**U.S. Department of Energy
Office of Environmental Management**

Paducah Gaseous Diffusion Plant

**Review Report: Groundwater
Remedial System Performance
Optimization at PGDP, Paducah,
Kentucky**

May 24, 2007

Figure 6. TCE Concentrations over Time in NE Plume Extraction Wells.

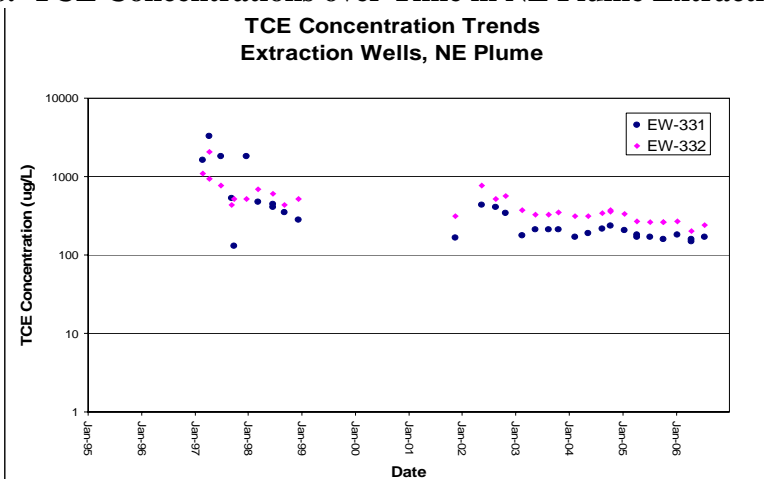
TCE concentrations throughout the Northeast Plume are below $1000 \mu\text{g/L}$ at extraction wells and monitoring wells. Concentrations of TCE over time at the extraction wells are presented in Figure 6. Figure 7 depicts a plot of TCE concentrations in MW292, located upgradient of the Northeast Plume extraction wells, from 1996 through 2004, and is representative of trends in other monitoring wells. It is inferred that concentrations are less than $1,000 \mu\text{g/L}$ up gradient of the extraction system along likely groundwater flow paths. The interim goal of the Northeast Plume Extraction System to control migration of water contaminated by $>1000 \mu\text{g/L}$ TCE has been achieved.

The Review Team recommends this system be placed in stand-by mode, with continued detection monitoring to assess the potential reappearance of TCE concentrations above 1000 $\mu\text{g/L}$. Decision criteria will need to be developed that clarify under what conditions the extraction system will be restarted based on observed TCE in designated performance monitoring wells located upgradient of the extraction system. It is possible that new monitoring well locations and/or target depths may be required for this purpose.

Figure 10. Location of Wells in the Vicinity of the Northwest Plume.

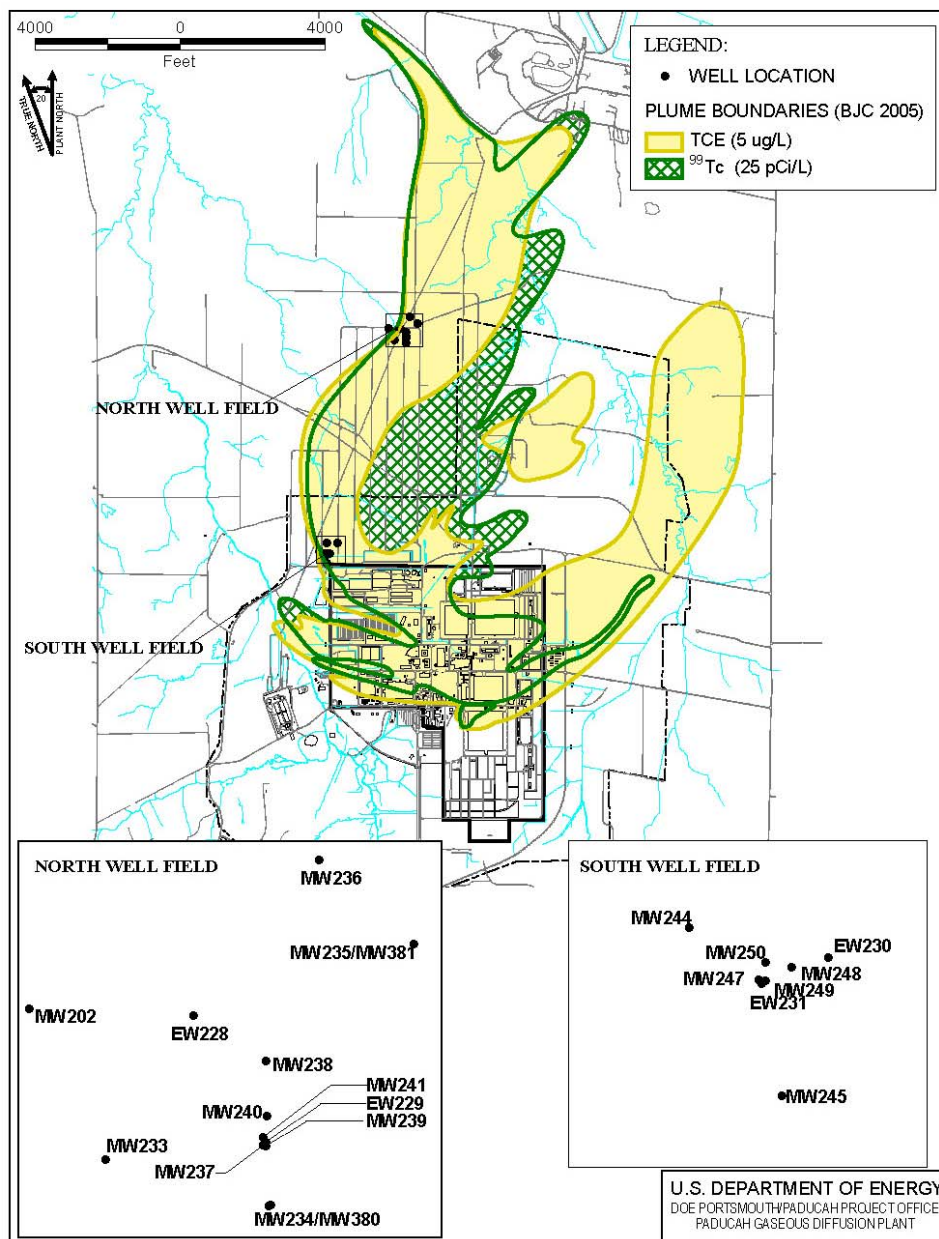
The Northwest Plume extraction system currently operates with two northern and two southern extraction wells, illustrated on Figure 10. The system operates at a total extraction rate of approximately 200 gallons per minute (gpm). System operators indicated that a total of approximately 80 gpm is extracted from the two northern wells,

EW 228 and EW 229, and a total of approximately 120 gpm is extracted from the two southern wells, EW 230 and EW 231. System operators also indicated to the Review Team that capacity of the treatment plant for the combined Northwest Plume system is approximately 225 gpm, and the recommended minimum plant flow rate is 160 gpm.

The Review Team recommends terminating the extraction at the two northern extraction wells, and increasing total extraction in the vicinity of the southern extraction wells by a similar amount (about 80 gpm). At this point, there is no reason to permanently dismantle these wells, the recommendation is only to terminate pumping from those wells. This design modification will increase contaminant mass removal and enhance capture near the southern extraction wells, which are closer to the contaminant sources. In turn, contaminant concentrations in groundwater should decrease downgradient, including discharges to Little Bayou Creek. The TCE concentrations in the northern portion of the plume have decreased significantly: from greater than 1000 $\mu\text{g/L}$ to a few hundred $\mu\text{g/L}$, or less. ^{99}Tc activities have also declined significantly; all monitoring wells in the northern portion of the plume are well below 900 pCi/L. This design modification does not require an increase in the capacity of the existing treatment plant.

Figure 11. TCE Concentrations over Time, Northern Extraction Wells.

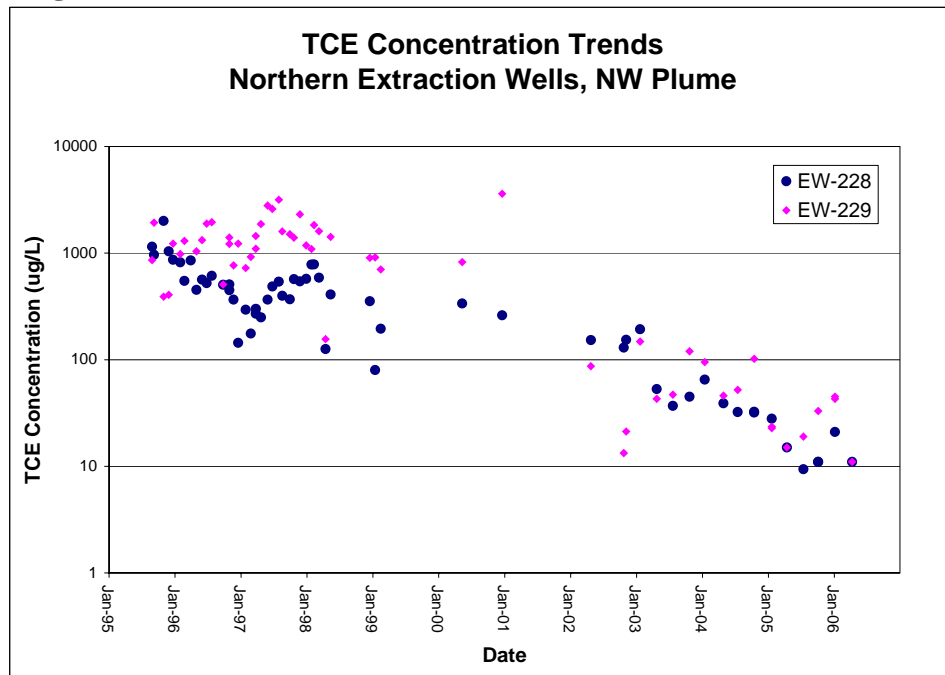
Figure 11 illustrates the TCE concentration reductions over time at the northern extraction wells. TCE concentrations at the two northern extraction wells have declined and are currently in the range of 10 to 50 µg/L.

A potential explanation for the concentration reductions at the northern extraction wells is the mass reduction provided by the southern extraction wells. Another potential explanation is a shift in the core of the TCE plume over time such that the northern extraction wells are no longer in the zone of highest concentration.

Figure 12. TCE Concentrations over Time, Southern Extraction Wells.

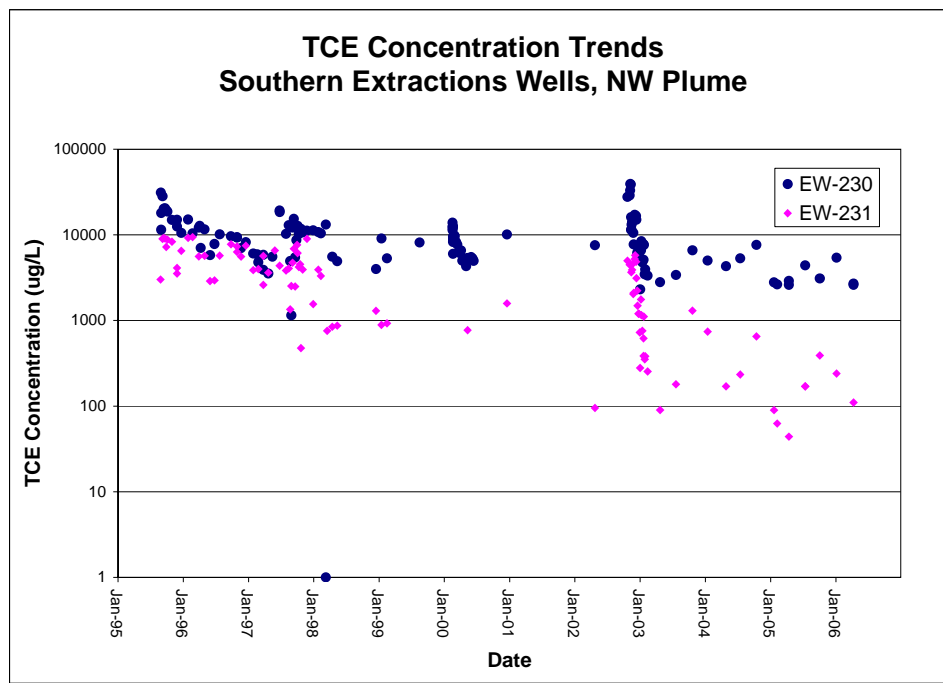
The southern extraction wells are currently extracting higher TCE concentrations than the northern extraction wells, as illustrated by comparing Figure 12 to Figure 11. In particular, EW 230 continues to extract TCE concentrations greater than 1,000 $\mu\text{g/L}$, and at times concentrations have spiked to more than 10,000 $\mu\text{g/L}$. Concentration reductions observed at EW 231 over time may represent a shift in the location of the plume core to the east, which could be caused by reductions in net recharge over time in the region between the Northwest Plume and the Northeast Plume. Such reductions in net recharge in that area could be due to changes over time in the use of lagoons and ditches over time, and/or due changes over time in the amount of water passed through pipes that might potentially leak.

Strategies for increasing extraction in the vicinity of the southern wells include the following:

- *Increase extraction at existing wells EW 230 and EW 231.* The advantage of this approach is that no new extraction wells and no new piping are required. The site team would establish the extent to which pumping at each well could be increased, based on specific capacity and available drawdown at each well. Pumping rate at each well would then be managed so that the well with the highest extracted concentrations would be pumped as much as possible, with the balance of the treatment plant capacity extracted from the other well. A disadvantage of this approach is that a total pumping rate approaching the treatment plant capacity may not be possible using just these two wells. Another disadvantage is that these wells may not be located in the core portion of the plume, either now or in the future.

- *Add additional extraction locations near EW 230 and EW 231.* The advantage of this approach is that it improves the potential for groundwater to be extracted from the core portion of the plume, which is expected to shift to the east over time due to reductions in anthropogenic net recharge to the east. This approach also

Figure 13. ^{99}Tc Concentrations over Time in Southern Extraction Wells.

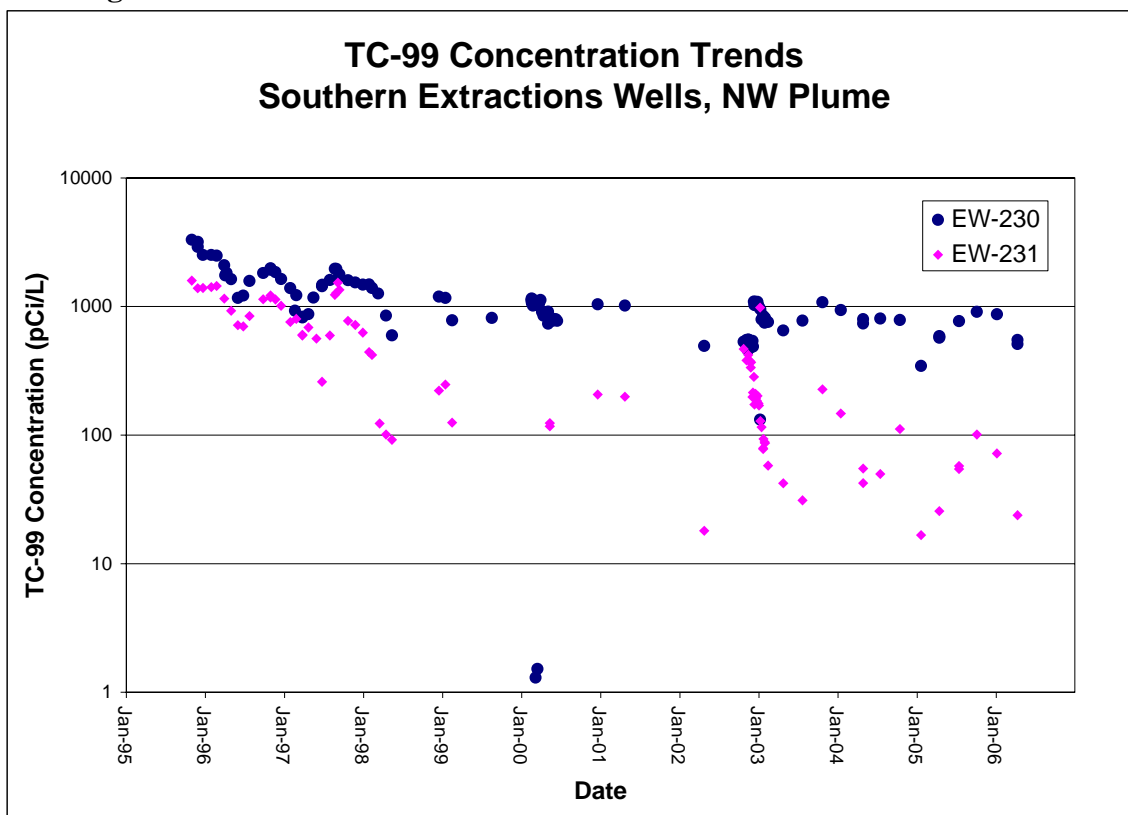
With respect to ^{99}Tc , both of the southern extraction wells currently have influent ^{99}Tc concentrations below the groundwater cleanup goal of 900 pCi/L (see Figure 13). The current state permit does not have an effluent criterion to surface water for ^{99}Tc . The plant is likely to be subjected to higher concentrations of ^{99}Tc . It is unlikely those concentrations will exceed historic concentrations during early plant operations, or the ion exchange system design concentration of 2000 pCi/L that the plant was able to treat to the required 25 pCi/L treatment goal. Treatment of ^{99}Tc to the treatment goal should

not be a problem with the current resin treatment process, even if influent concentrations increase above 900 pCi/L as a result of implementing this recommendation.

Figure 14. Schematic of a Geosiphon.

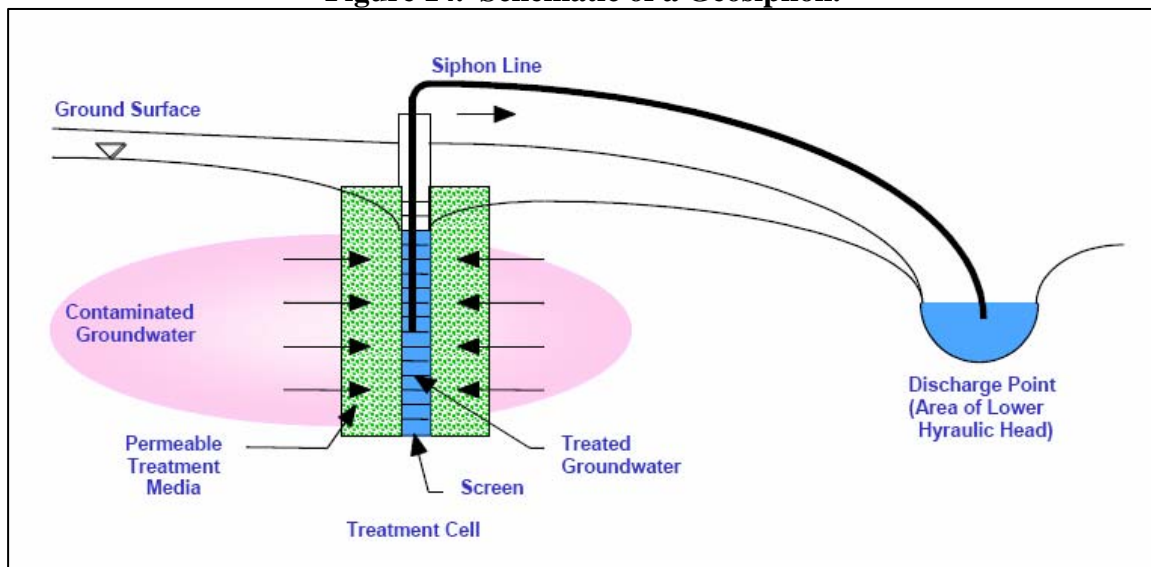
Another alternative is a geosiphon. A geosiphon is able to extract water from the subsurface without the use of a pump by allowing the extracted water to discharge at a lower water level than the water level at the extraction point. This may either be used to induce more concentrated flow to pass through in-ground treatment media (e.g., zero-valent iron) surrounding the extraction well (see the schematic in Figure 14), or to direct contaminated water to a treatment vessel located downhill nearer the extraction point. Such a system has been installed at the Savannah River Site (see <http://www.rtdf.org/PUBLIC/permbarr/prbsumms/profile.cfm?mid=36>). This could be used in conjunction with enhanced aeration to restore oxygen to the treated water prior to discharge into Little Bayou Creek. The long-term performance of such a siphon would need to be verified, particularly as water levels are drawn down near the seeps. Note that the use of zero-valent iron may result in concentration of ^{99}Tc in a near surface location.

Figure 15. TCE Concentrations over Time in MW84.
(Note that boxes are the detection limits for the analyses)

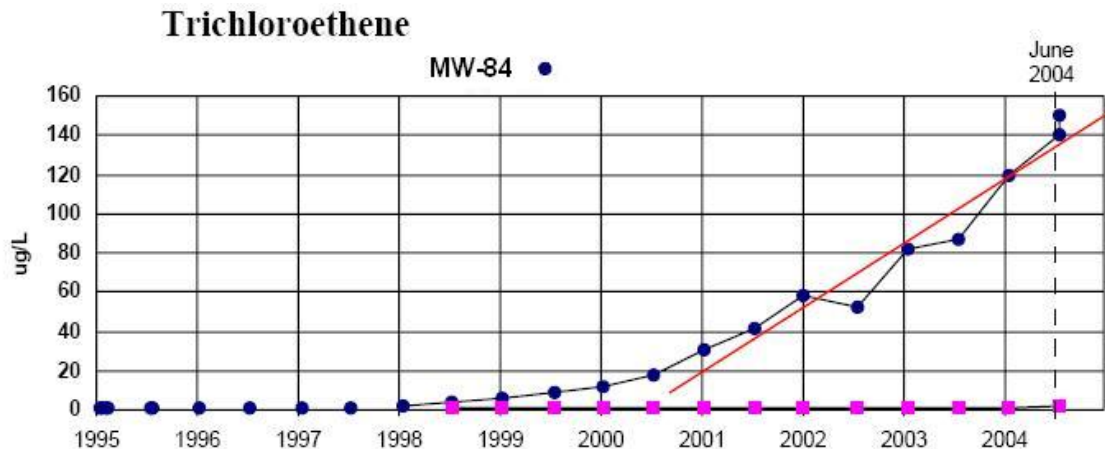
The Review Team also notes that the downgradient extent of the Southwest Plume is poorly constrained. Monitoring points in the program downgradient of MW354 are sparse. Additional permanent monitoring points, spanning the vertical extent of the RGA, in the vicinity of Bayou Creek are warranted, and would serve to validate and model predictions, as well as observations of the Review Team noted in this report. Note that if plant effluent discharge to the Outfall Ditch north of the Southwest Plume continues to diminish, the Southwest Plume may migrate on a more northerly heading and may merge with the Northwest Plume. (Refer to the following discussion regarding other potential plume changes, if operations at the facility substantially diminish.) There is evidence for such a shift towards the east already occurring. Monitoring wells 84, 86, and 87 display a significant increase in TCE concentrations since 2000, as shown in Figure 15. Middle RGA well MW84 first displayed this trend, followed by the co-located but deeper MW86 (lower RGA), and then by MW87 located farther east. Such trends should be tracked closely.

Figure 16. Effluent ^{99}Tc Concentrations over Time from Lead Ion-Exchange Vessel.

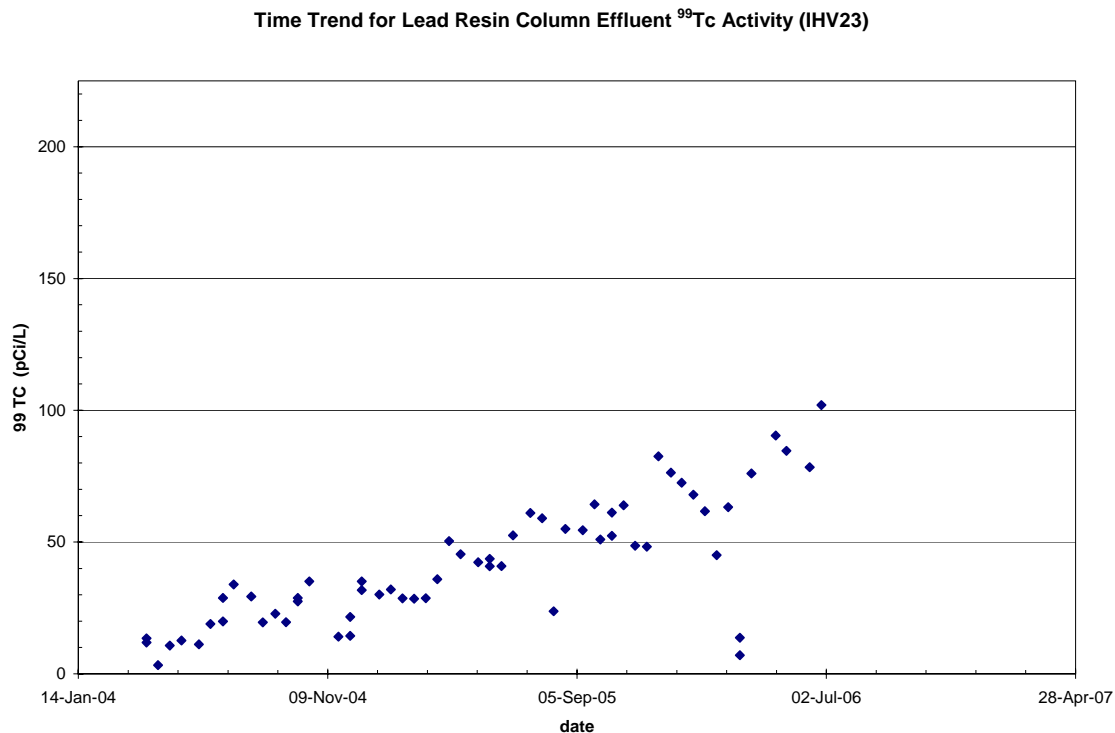
The current protocol requires the resin be changed when the concentration in the effluent stream from the lead column reaches 50% of the plant influent concentration. This result is a variable concentration at which the column resin is changed out, as well as the variable activity present in the resin disposed. It appears that this protocol results in wasted resin exchange capacity. The PDGP technical team should re-evaluate whether treatment is needed for influent ^{99}Tc levels below the treatment goal. If the decision is made to continue treatment, then the appropriate effluent quality should be assessed. If an effluent activity level above the current 25 pCi/L is endorsed, then other options such as split ^{99}Tc treatment can be evaluated (i.e., treat only enough water to meet the effluent standard, bypassing the rest), or allowing the resin to operate until the lead exchange column is fully exhausted.

A plot of the effluent concentration over time, as shown in Figure 16, indicates the current resin exchanges the ^{99}Tc over a long period of time and does not break through abruptly. This is indicative of a resin that has significant exchange capacity remaining when the resin is changed out at a concentration corresponding to 50% of the influent concentration. The facility should implement a plan to monitor the lead column to extend its operation cycle to correspond to 90 – 100% breakthrough. Given the low

concentration of ^{99}Tc in the influent relative to the groundwater cleanup goal, the exchange capacity present in the down stream columns will likely meet the 25 pCi/L effluent design criteria, and if that level is exceeded, the effluent concentration will still be well below the groundwater cleanup goal. The Review Team notes that extending the use of the lead column until it is fully exhausted will cause the ^{99}Tc activity level in the resin to increase, which could impact future disposal options. A discussion of disposal options is included below.
